DRAINAGE LETTER

ROLLING THUNDER BUSINESS PARK, FILING 1B

A REPLAT OF LOT 11, ROLLING THUNDER BUSINESS PARK

Please add PCD File No. PPR2124

AS REPLATTED

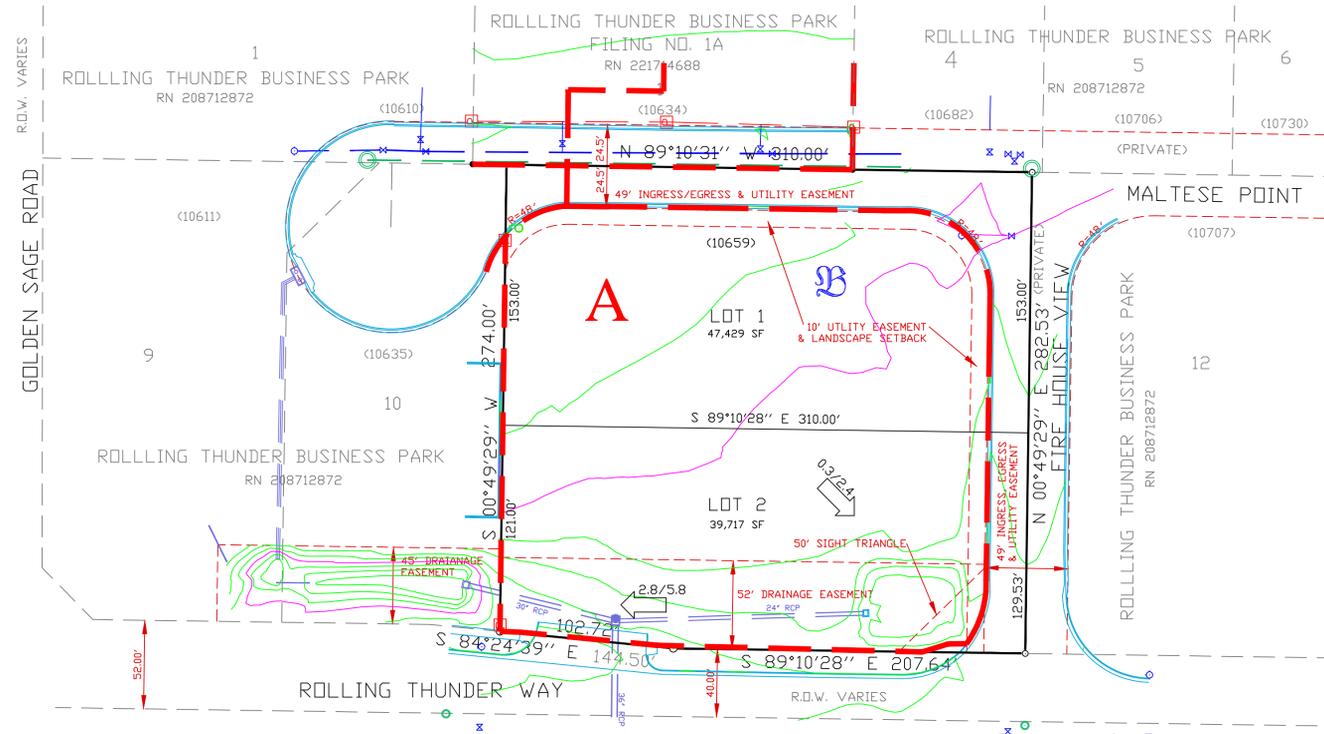
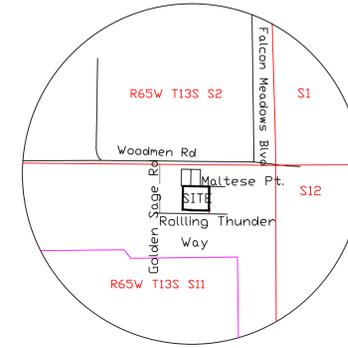
Please increase the scale of the drawing for clarity.

DRAINAGE PLAN

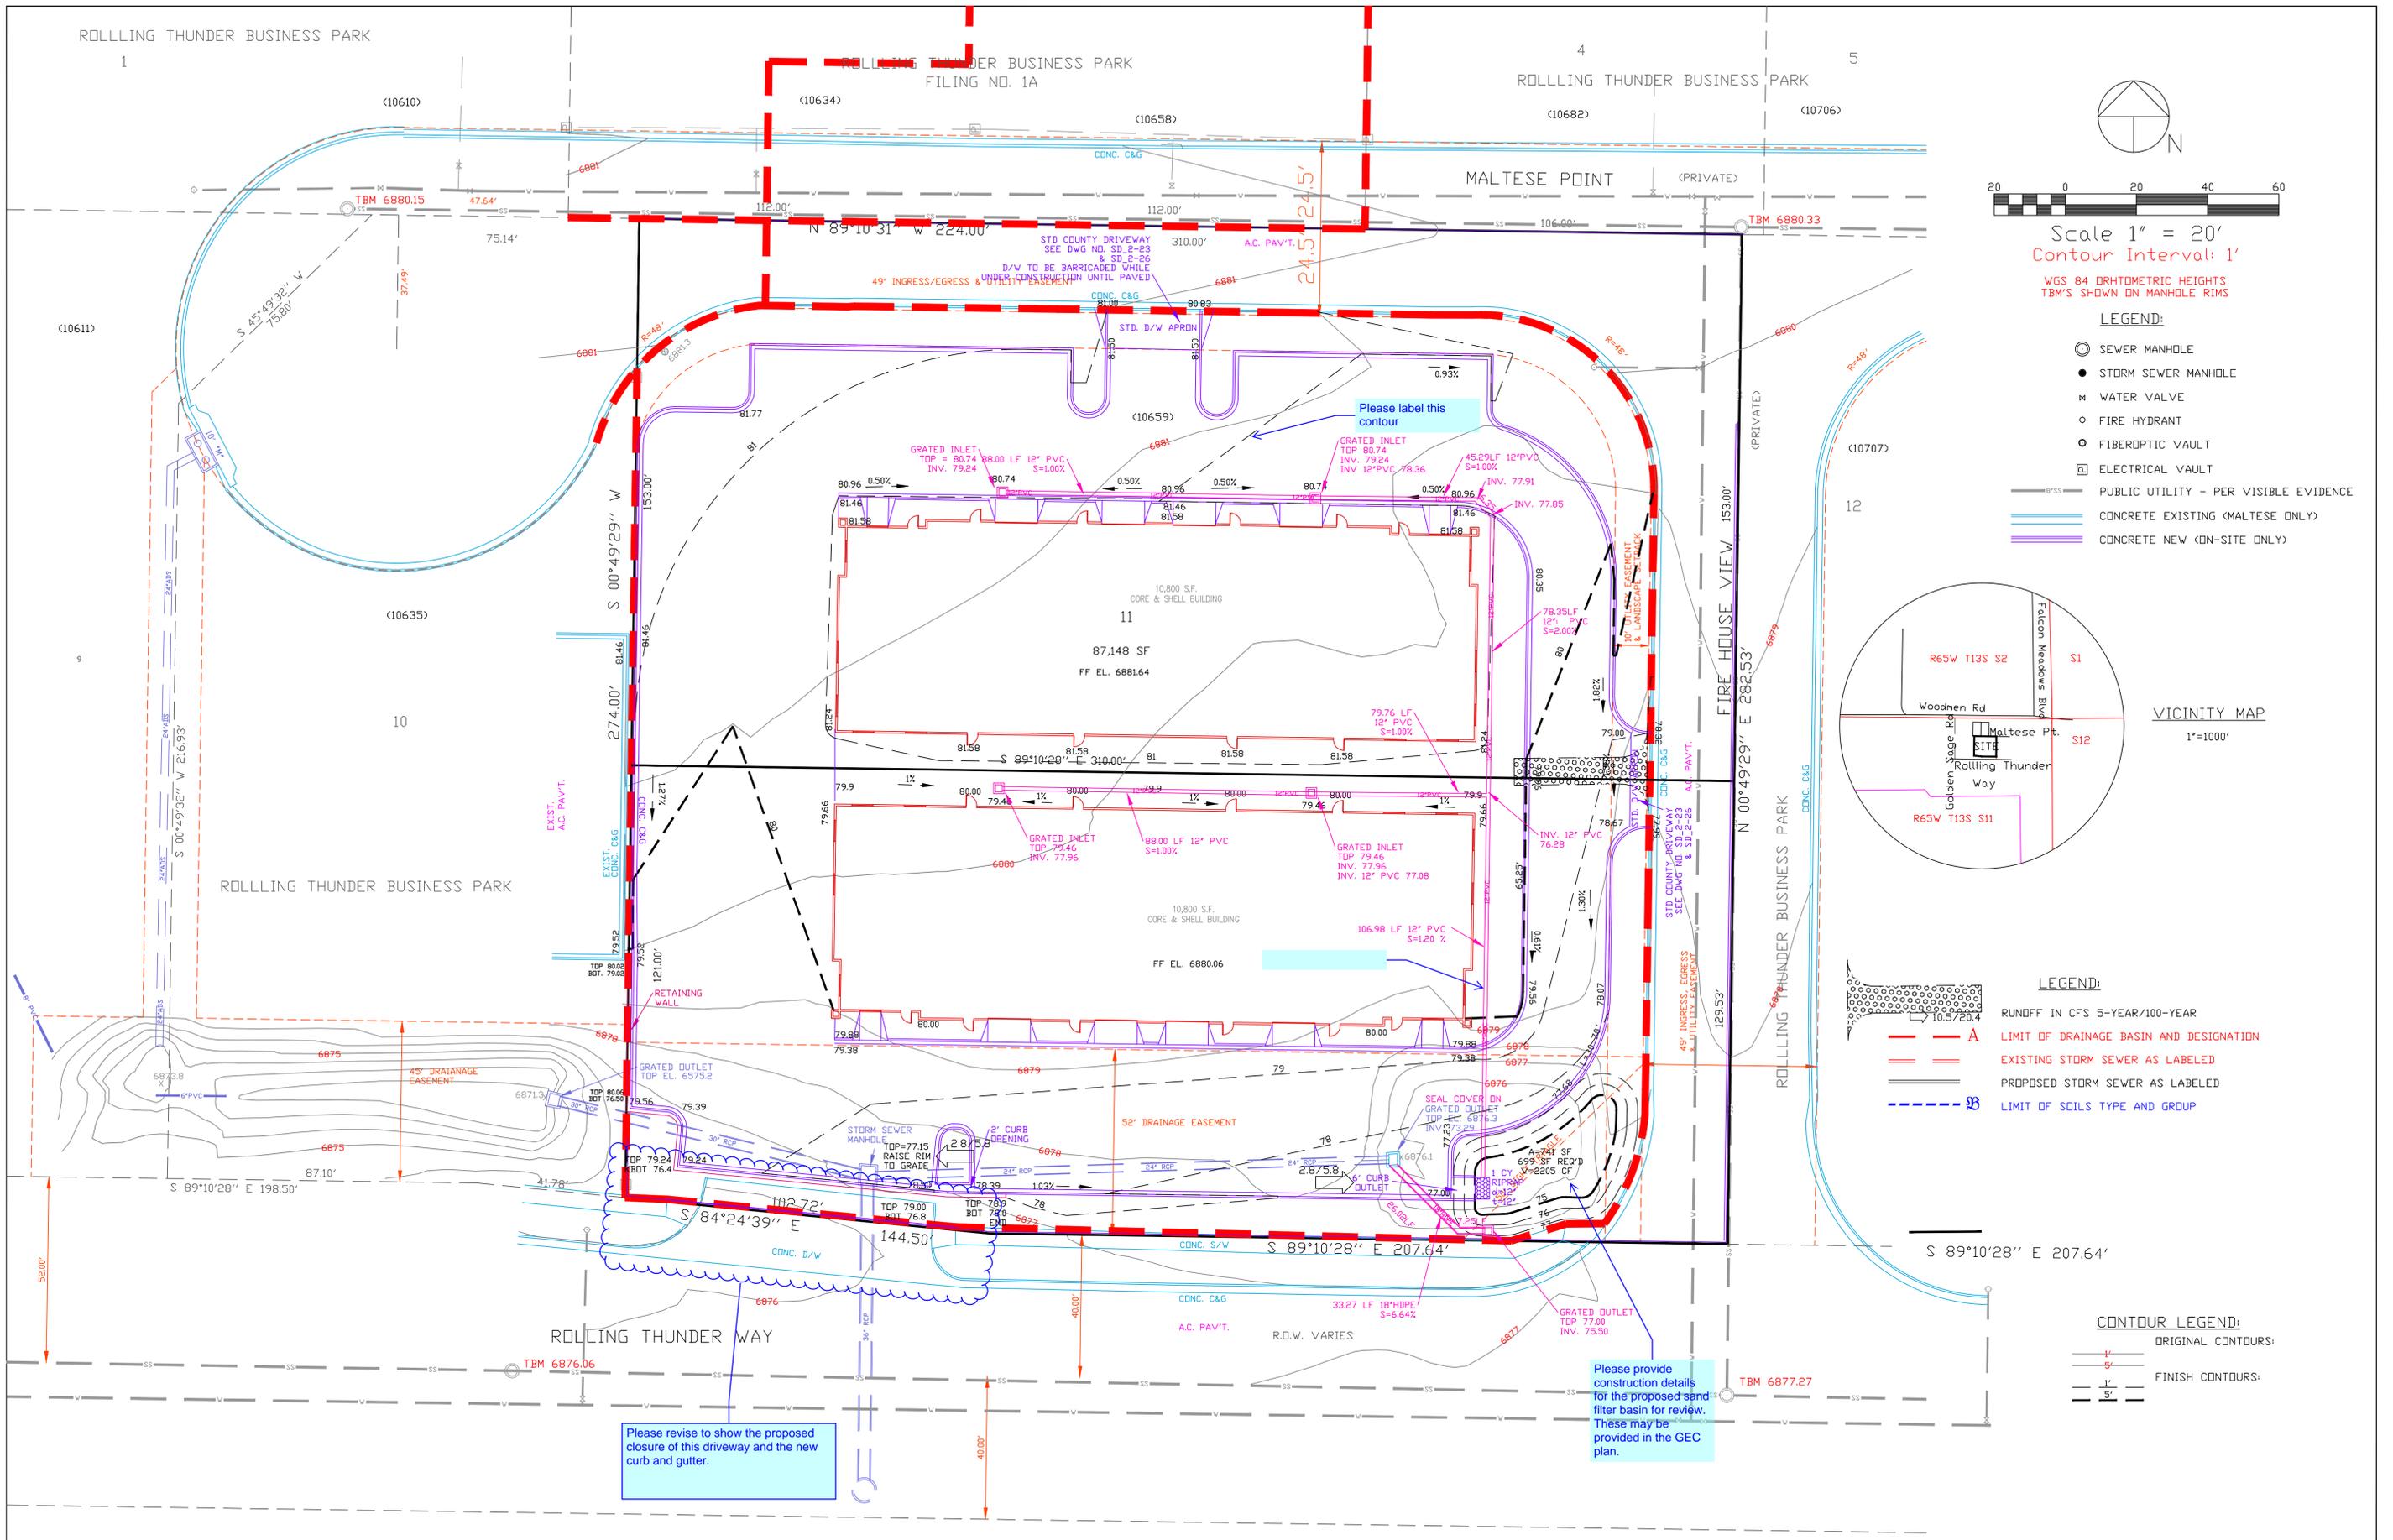
Please revise to show the proposed closure of this driveway and the new curb and gutter.

Please provide construction details for the proposed sand filter basin for review. These may be provided in the GEC plan.
